# Wisconsin Department of Transportation

**Proposal #04: 1080-13-70, WISC 2015 466**  
**Lake Geneva - Elkhorn**  
**CTH NN Interchange**  
**USH 12**  
**Walworth County**

This is Addendum No. 01, which provides for the following:

**ADDENDUM NO. 01**

Addendum No. 01  
ID 1080-13-70  
Revised Sheet 39  
August 4, 2015

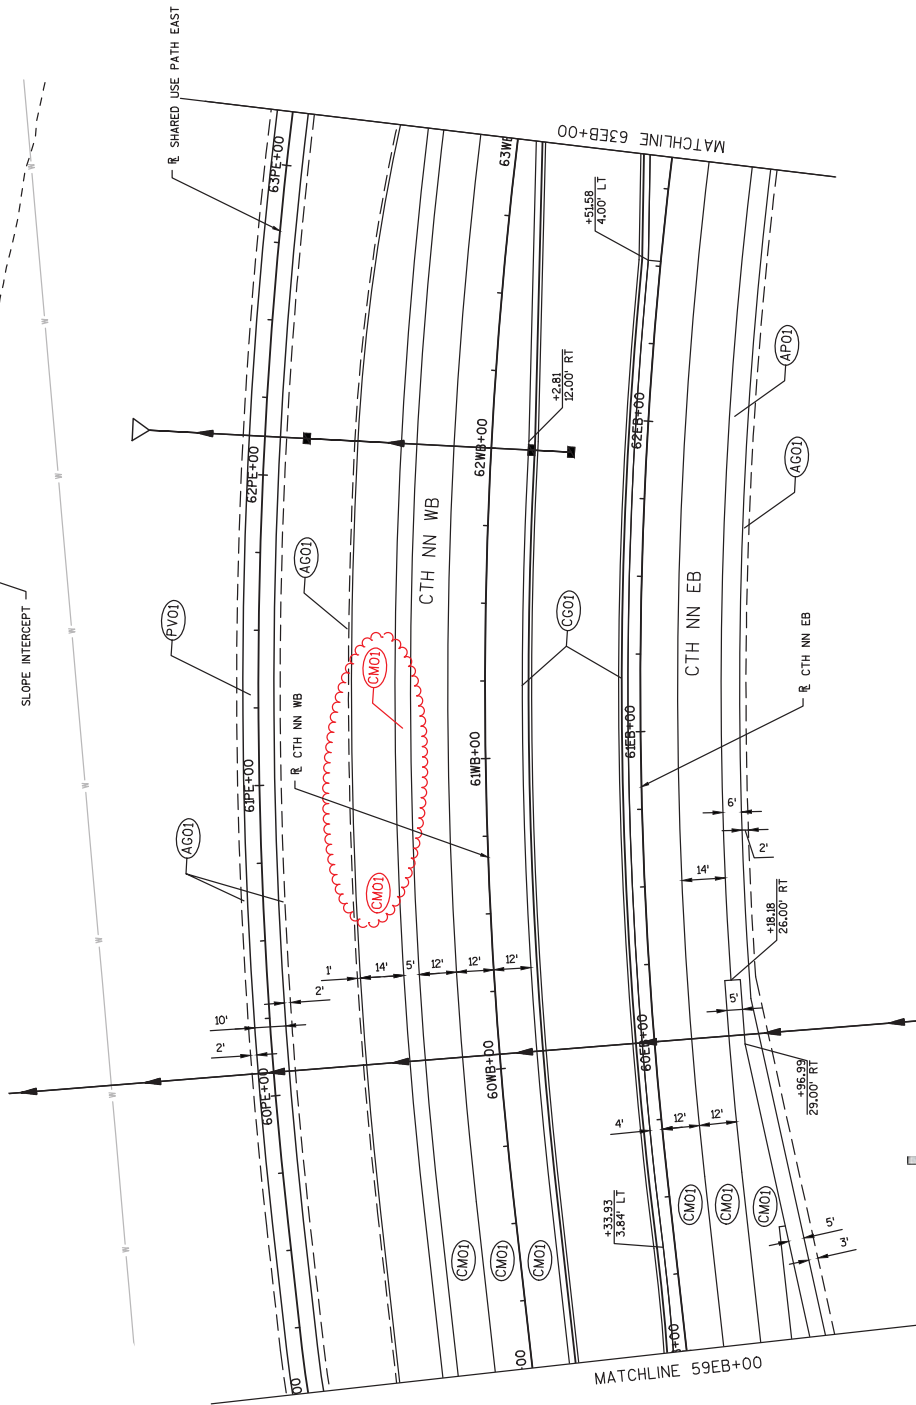
Revised Plan Sheets	
Plan Sheet	Plan Sheet Title (brief description of changes to sheet)
39	Plan Detail – CTH NN (revised callout for Bray Road turn lane pavement)
495	Structure B-64-186, 45W” Prestressed Girder – 1 (clarified the number of girders)
510 & 511	Structure R-64-18 (revised the top of wall elevations)
515 & 516	Structure R-64-19 (revised the top of wall elevations)

**Addendum No. 01**  
**ID 1080-13-70**  
**Revised Sheet 510**  
**August 4, 2015**

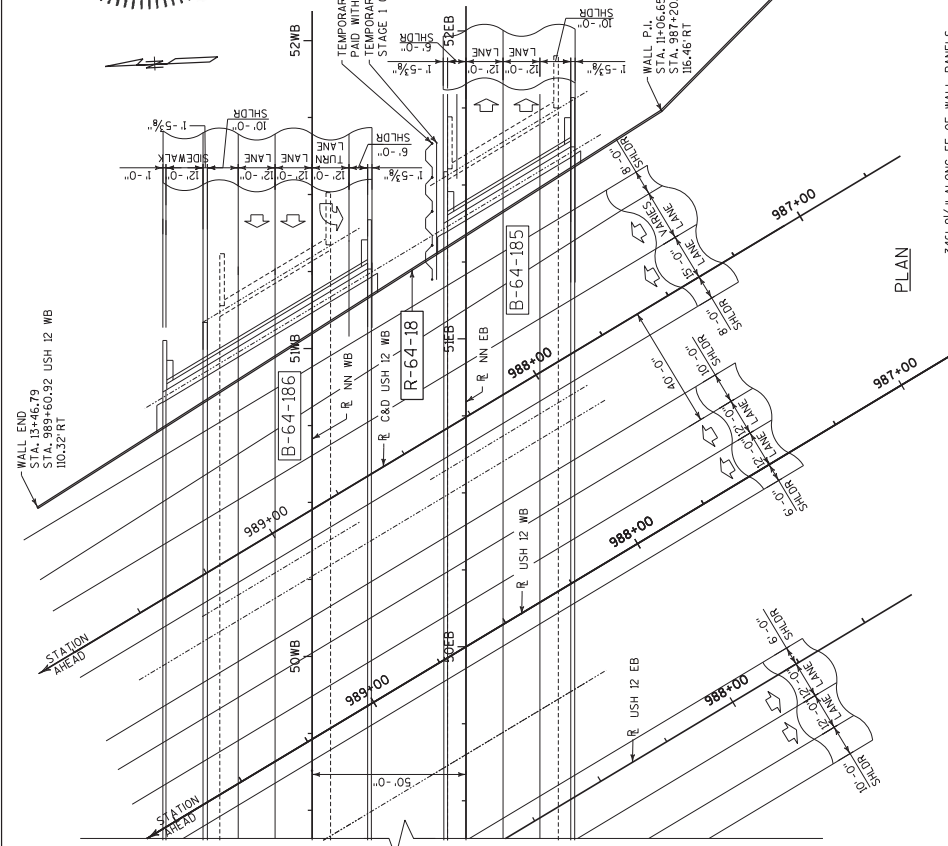
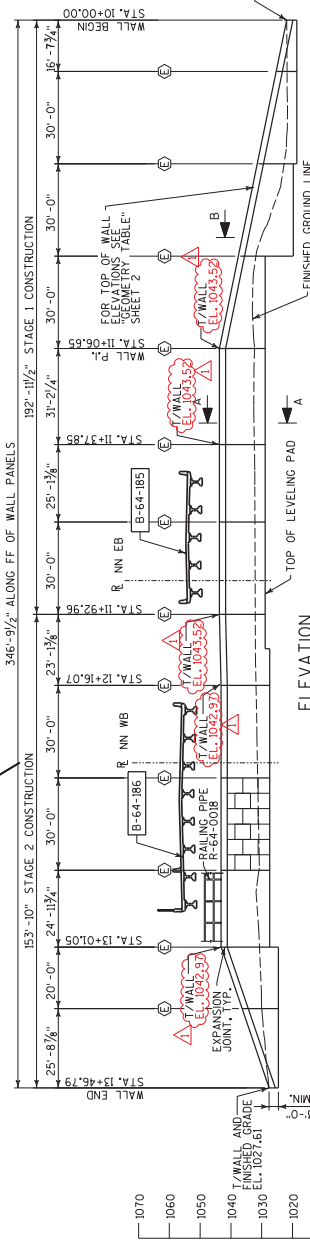
NO.	DATE	TOP OF WALL ELEVATIONS	REVISION	BY	ACT
1	7/30/15

Addendum No. 01  
ID 1080-13-70  
Revised Sheet 516  
August 4, 2015

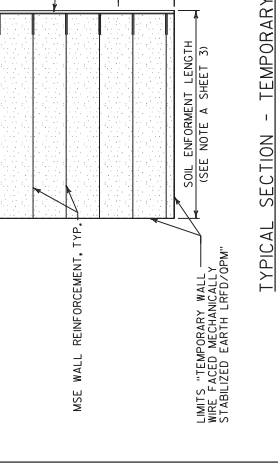
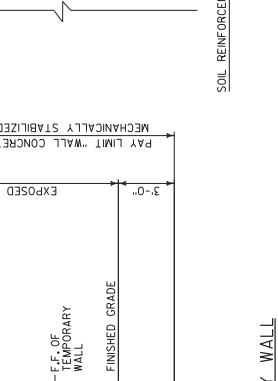
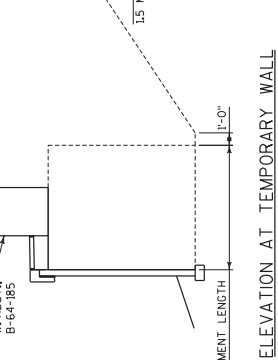
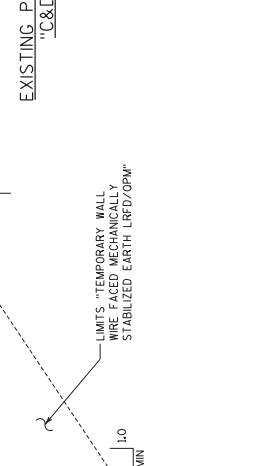
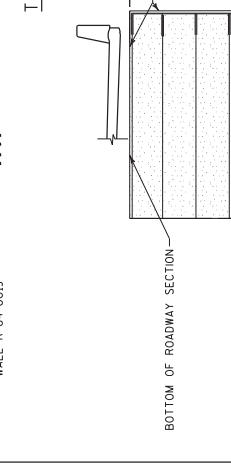
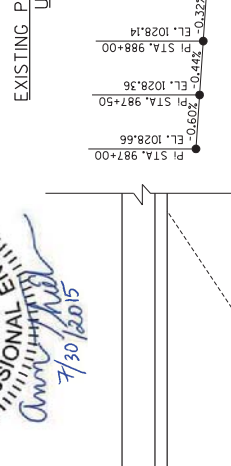
NO.	DATE	REVISION	BY
1	7/30/15	TOP OF WALL ELEVATION & QUANTITY	ACT
